**From:** Lindsey Ozbolt  
**Sent:** Friday, January 27, 2017 4:18 PM  
**To:** 'Nate Thompson'  
**Subject:** RE: ELST 60% Plan Homeowner Feedback - 2325 East Lake Sammamish PL SE - Signed Letter

Subject: East Lake Sammamish Trail Segment 2B

**From:** Craig [mailto:craig.o@comcast.net]  
**Sent:** Friday, January 27, 2017 8:01 AM  
**To:** Lindsey Ozbolt <LOzbolt@sammamish.us>  
**Cc:** Lyman Howard <lhoward@sammamish.us>; Don Gerend <dgerend@sammamish.us>; Tom Hornish <THornish@sammamish.us>; Kathleen Huckabay <KHuckabay@sammamish.us>; Bob Keller <BKeller@sammamish.us>; Christie Malchow <CMalchow@sammamish.us>; Tom Odell <todell@sammamish.us>; Ramiro Valderrama-Aramayo <RValderrama-Aramayo@sammamish.us>  
**Subject:** Comments/Questions for ELST 60% Design & SSDP

**RE: East Lake Sammamish Master Plan Trail South Sammamish Segment B**

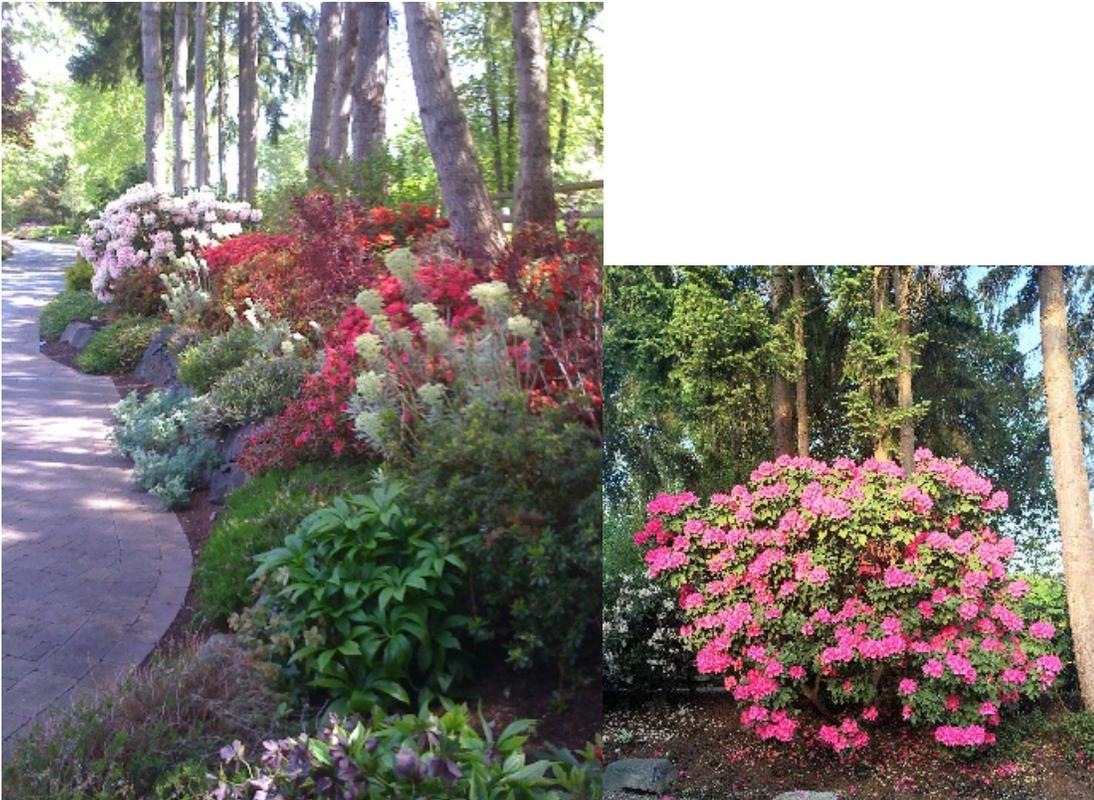
The picture below is the segment of the trail segment in question (looking south). Keeping the trail in its current location or moving it eastward would mitigate the loss of the current flora and fauna. Otherwise everything seen in this picture and westward including the trees and shrubbery along the fence below would be cleared – including the decades old Aspen and Douglas fir trees – ten in total. This entire section of the ROW would be denuded from the split-rail fence to 25 feet to the west. Nothing would be preserved based on the proposed King County trail plan.

In addition to my concerns about moving the trail westward, the trail plan shows a line where all landscaping of any kind is slated for “Clearing and Grubbing” (C&G) up to that line which I understand is the entire 25 feet west of the current split-rail fence. That act of C&G is so shocking, emotionally disturbing, and impactful that I would appreciate consideration to mitigate the incredible loss of the current trees and shrubbery by moving the C&G line eastward. Removal of every piece of landscaping within the border of the C&G seems unconscionable, wasteful, and expensive. The picture below on the left is looking north and that landscaping you see would be wiped clean under the proposed trail C&G process. The picture below on the right is one of many large mature rhododendrons in the ROW. That would be cut down along with all the others large rhododendrons and azaleas within the County ROW. There are probably at least 25. Some were already located in the ROW when I purchased the property 20 years ago. They would all be cut down, not because the trail would be located in that space but merely because the construction requires “C&G” of everything in its path. All shrubbery and trees to be bulldozed; the landscape to be denuded; everything goes under the proposed trail plan. Absolutely nothing is to be preserved in the ROW under the proposed trail plan.

Under the County’s plan all that we see in these pictures above will be gone. The trees and shrubbery cut down and all the landscaping dug up and thrown away. Under the County’s plan nothing in these pictures will be preserved or left behind. Under the County’s plan the land will be denuded, completely stripped of everything. 25 feet by 250 feet – that’s 6,250 square feet laid bare saving only the largest of the Douglas fir trees and cutting down all the rest. I think it ironic that the County has so meticulously laid plans to “preserve” a piece of ROW (Section 23C) that has no value, no beauty, and no habitat because the Corps called out “wetland”. Is there no value placed on decades-old trees and shrubbery and the wildlife that lives there in the ROW? To me it is tragic and farcical to pursue denuding the ROW as planned by the County. It is madness to me and I believe it makes no sense whatsoever. I implore to whoever has power at King County or the City of Sammamish to make modifications to the trail plan and reconsider not to move the proposed trail westward. Keep it where it is or move it eastward instead. And please revisit the C&G impact. Why denude? Please save the beautiful habitat inside the ROW for all to enjoy. Thank you!
